Official Notification Federal Boat Safety Act Manual Starter Interlock Lever Replacement 30/40, and 55/60 Marathon/SeaPro

Mariner and Mercury

1994 and 1995 Manual Starter Models 30/40, and 55/60 Marathon/SeaPro.

Figure 2. Interlock Lever Installation.

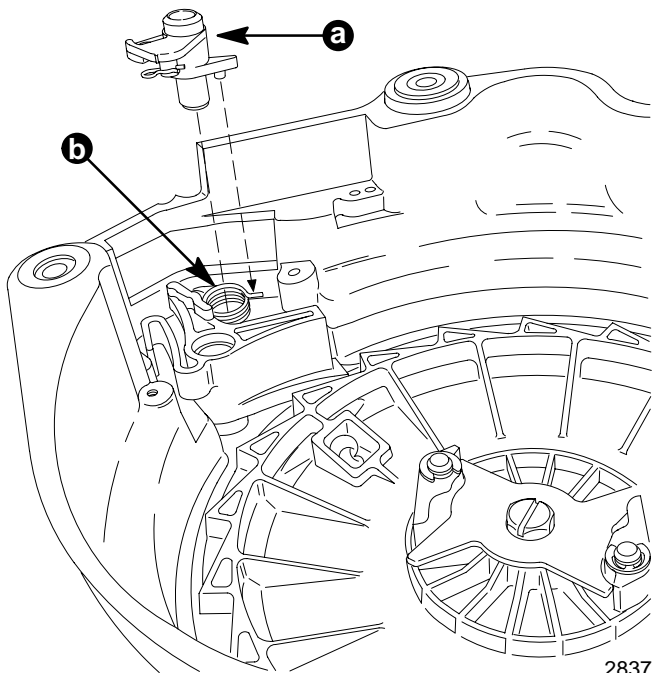
Outboards listed, require replacement of the starter interlock lever. Due to a defect in material, the spring portion of the interlock lever has the potential to break off and allow the engine to start with the outboard shifted into gear.

6. Remove cam retainer (Figure 2).
7. Replace Interlock Lever with new lever (p/n 816690--2) marked with a "A".

- a - Cam Retainer
- b - Interlock Lever "A" Mark

Figure 5. Good Interlock Lever

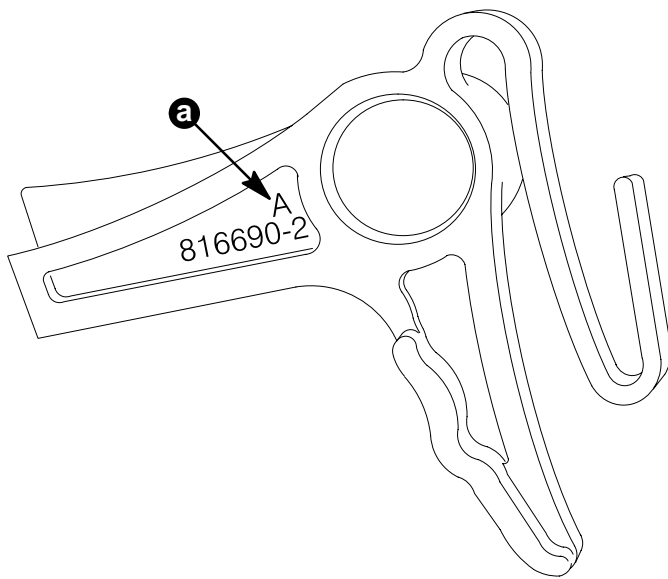
Inspect all p/n 816690--2 starter interlock levers in your service stock. Return with a warranty claim, any interlock levers that do not have the cast mark “A” above the part number on the lever (Figure 5). Interlock levers in your stock that have the cast mark “A” are good serviceable parts.

a - Interlock Lever “A” Mark
